# BHPC MEETING PACKET

Thursday January 23, 2025 5:00 p.m. EST Prepared by HAND Staff

# **Bloomington Historic Preservation Commission Meeting**

# **AGENDA**

Comments on 910 N Maple Street revised plan

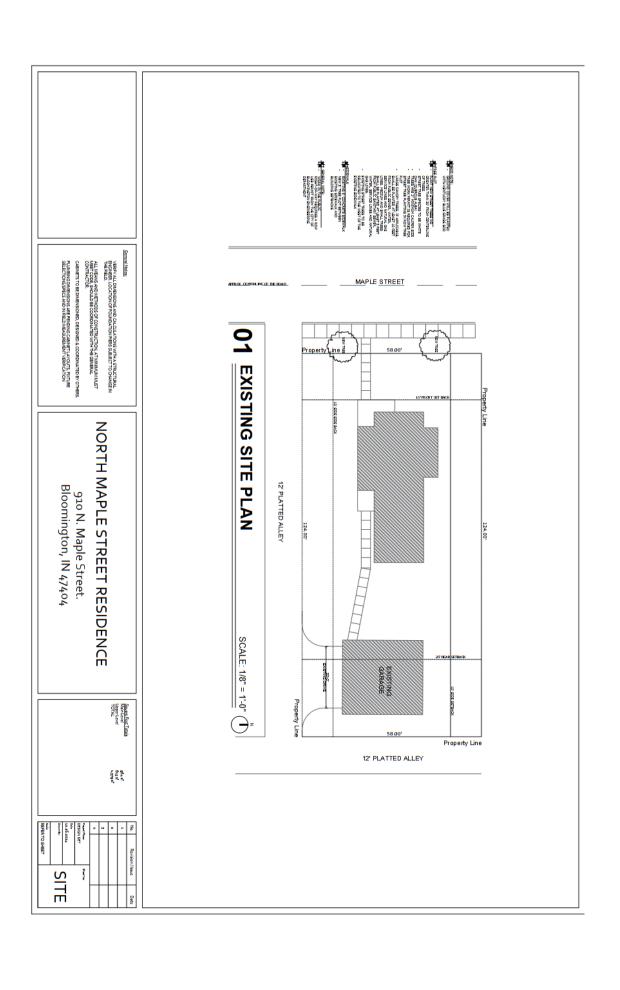
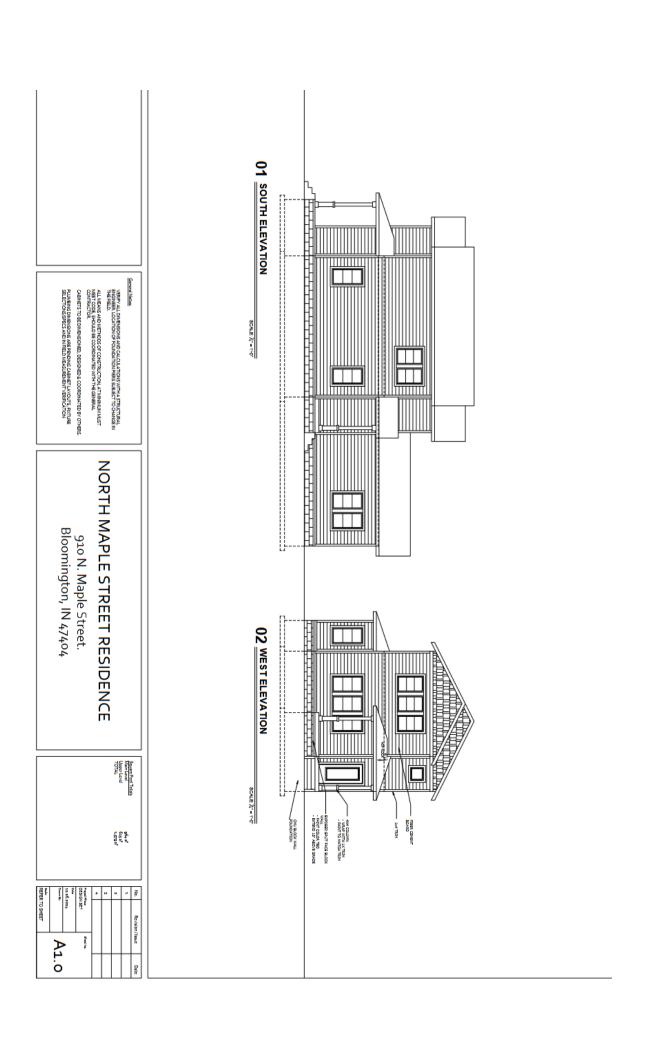
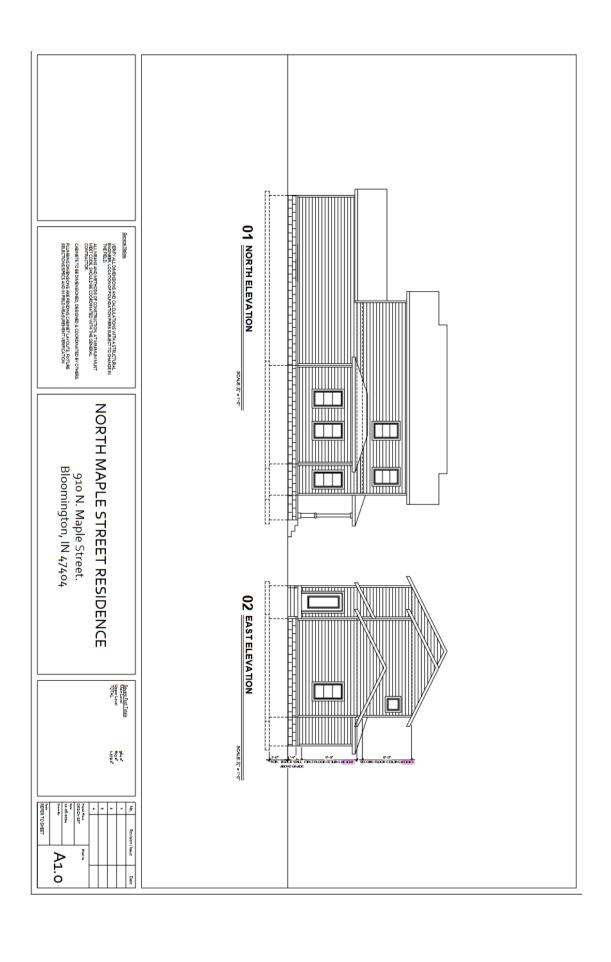
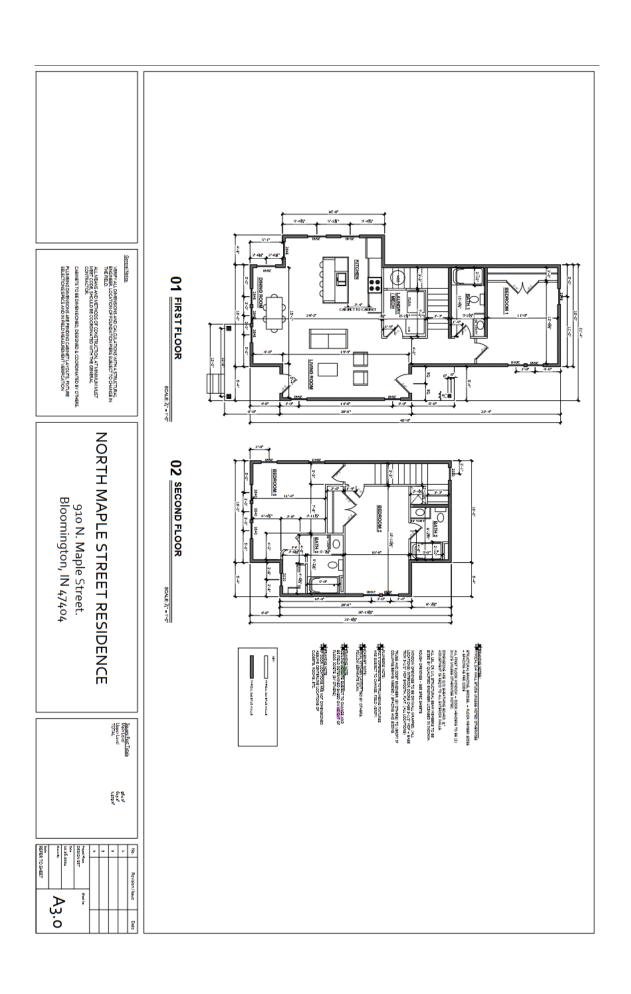
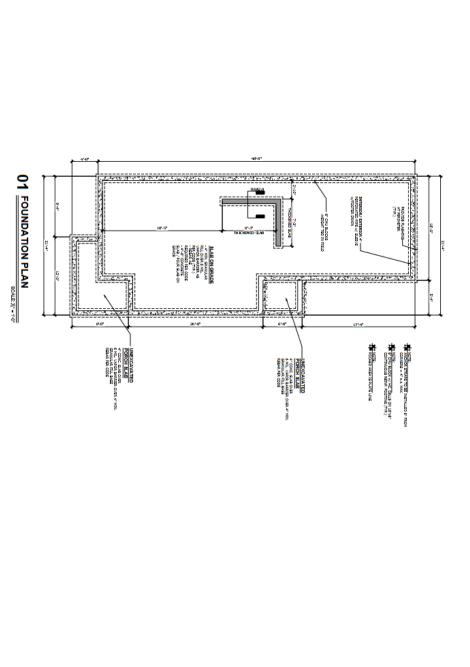
20 West Elevation:

The petitioner told us by email on 1-14-2025 that there would be no stone on the façade, that this was an error, and that he was planning to use horizontal siding (and, at the top, wooden shake siding). We concur that we prefer horizontal siding, not stone. However, the current plan indicates "horizontal vinyl siding": at our December 11, 2024 meeting with the petitioner, he had said the siding would likely be fiber cement, which

we prefer for new construction

01 North Elevation: At the December 11 meeting with the petitioner, we noted that there were only three windows on this side. We note the addition of several windows on the bumpout, but it appears that 2/3 of that wall is still windowless. We wonder whether additional fenestration can be added on that side. Lack of windows on half of the outer wall gives the structure a fortress-like appearance. This will be visible from the public right-of-way.

Building height: We would still like to see the total building height from ground (at grade) to roof peak. We cannot tell without more context whether this building will appear significantly taller than surrounding houses on the block, especially given that it is at the crest of a hill. Ensuring building height compatible with surrounding structures was one of the major points we discussed with the petitioner on 12-11-24.
